Access Compliance Report

Public Rights-of-Way

(Curb Ramps)

Intersection ID: 11176	Main Street: AVENSONG_CROSSING_DR	Cross Street: CELLO_CT	Location: NW
ADA ID: 2CACCA09357D	Ramp Type: BlendTrans1	Initial Pass/Fail: Fail	Overall Compliance: No
Severity Score: 10			
Codes/Mitigation Info/Possible Solution		Field Measurements/Component Compliance

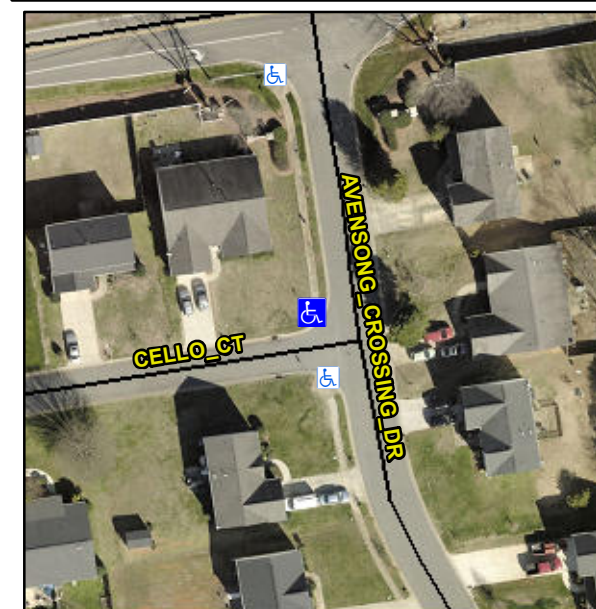
NO LT SW

Not Found, R304.5.1, R304.5.3

Compliance	Description	Data	Compliance	Description	Data
N/A	Ramp Length (in)	45.0	Yes	BlendTrans Slope (%)	4.0
No	Ramp Width (in)	38.0	No	BlendTrans XSlope (%)	2.2
N/A	Flare Type LT	N/A	N/A	Flare Type RT	N/A
N/A	Flare Slope LT (%)	N/A	N/A	Flare Slope RT (%)	N/A
N/A	Flare Traversable LT?	N/A	N/A	Flare Traversable RT?	N/A
N/A	Landing Length (in)	N/A	N/A	DWS Provided?	N/A
N/A	Landing Width (in)	N/A	N/A	DWS Contrast?	N/A
N/A	Landing Slope (%)	N/A	N/A	DWS Length (in)	N/A
N/A	Landing X Slope (%)	N/A	N/A	DWS Full Width?	N/A
N/A	Landing Curb? (Y/N)	N/A	N/A	DWS Offset (in)	N/A
N/A	Shared Landing?	N/A			
N/A	Gutter Ponding?	N/A	N/A	Gutter Slope (%)	N/A
N/A	Gutter Lip Ht (in)	0.5	N/A	Gutter X Slope (%)	N/A
N/A	Painted X Walk1?	No	N/A	Painted X Walk2?	N/A
	X Walk 1 Direction	To S		X Walk 2 Direction	N/A
	X Walk 1 Width (in)	N/A		X Walk 2 Width (in)	N/A
	X Walk 1 Slope (%)	1.4		X Walk 2 Slope (%)	N/A
	X Walk 1 X Slope (%)	1.4		X Walk 2 X Slope (%)	N/A

N/A	Ramp inside XWalk1?	N/A	N/A	Ramp inside XWalk2?	N/A
	Road Slope (%)	1.4		Clear Space?	N/A
	Road X Slope (%)	1.4	N/A	Clear Space to XWalk (in)	N/A
N/A	Any Obstructions?	N/A	N/A	Storm Grate/Utility Hazard?	N/A
	Obstruction Type			Storm Grate/Utility Type	
		N/A			N/A
			Yes	Surface Condition? (G/P)	Good
			No	Curb Slope (%)	11.3

Remove & Replace Curb Ramp With Two New Directional Ramps or Equivalent.
